Access Compliance Report

Public Rights-of-Way

(Curb Ramps)

Intersection ID: 5291	Main Street: LEX_DR	Cross Street: MARY_ALEXANDER_RD	Location: NW
ADA ID: 220B1143B292	Ramp Type: BlendTrans2	Initial Pass/Fail: Fail	Overall Compliance: No
Severity Score: 12.5			
Codes/Mitigation Info/Possible Solution		Field Measurements/Component Compliance

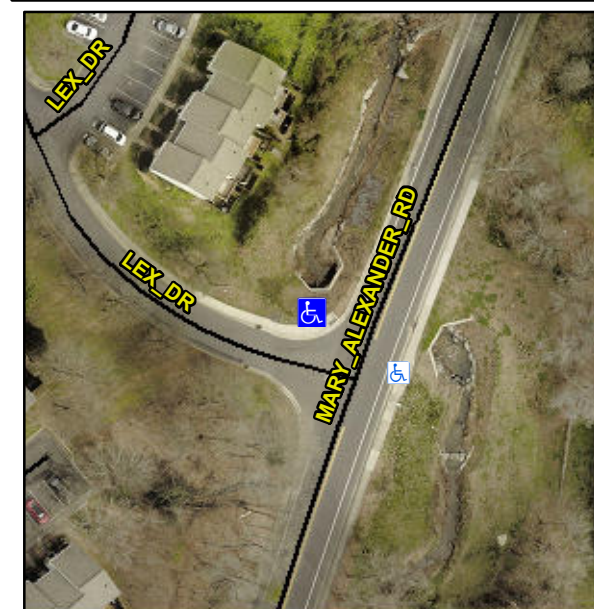
Not Found, R304.5.3

Compliance	Description	Data	Compliance	Description	Data
N/A	Ramp Length (in)	58.0	Yes	BlendTrans Slope (%)	0.9
Yes	Ramp Width (in)	56.0	No	BlendTrans XSlope (%)	5.8
N/A	Flare Type LT	N/A	N/A	Flare Type RT	N/A
N/A	Flare Slope LT (%)	N/A	N/A	Flare Slope RT (%)	N/A
N/A	Flare Traversable LT?	N/A	N/A	Flare Traversable RT?	N/A
N/A	Landing Length (in)	N/A	N/A	DWS Provided?	N/A
N/A	Landing Width (in)	N/A	N/A	DWS Contrast?	N/A
N/A	Landing Slope (%)	N/A	N/A	DWS Length (in)	N/A
N/A	Landing X Slope (%)	N/A	N/A	DWS Full Width?	N/A
N/A	Landing Curb? (Y/N)	N/A	N/A	DWS Offset (in)	N/A
N/A	Shared Landing?	N/A			
N/A	Gutter Ponding?	N/A	N/A	Gutter Slope (%)	N/A
N/A	Gutter Lip Ht (in)	N/A	N/A	Gutter X Slope (%)	N/A
N/A	Painted X Walk1?	No	N/A	Painted X Walk2?	N/A
	X Walk 1 Direction	To E		X Walk 2 Direction	N/A
	X Walk 1 Width (in)	N/A		X Walk 2 Width (in)	N/A
	X Walk 1 Slope (%)	3.3		X Walk 2 Slope (%)	N/A
	X Walk 1 X Slope (%)	3.8		X Walk 2 X Slope (%)	N/A

N/A	Ramp inside XWalk1?	N/A	N/A	Ramp inside XWalk2?	N/A
	Road Slope (%)	3.8		Clear Space?	N/A
	Road X Slope (%)	3.3	N/A	Clear Space to XWalk (in)	N/A
N/A	Any Obstructions?	N/A	N/A	Storm Grate/Utility Hazard?	N/A
	Obstruction Type			Storm Grate/Utility Type	
		N/A			N/A
			Yes	Surface Condition? (G/P)	Good
			No	Curb Slope (%)	7.7

Remove & Replace Curb Ramp With Two New Directional Ramps or Equivalent.
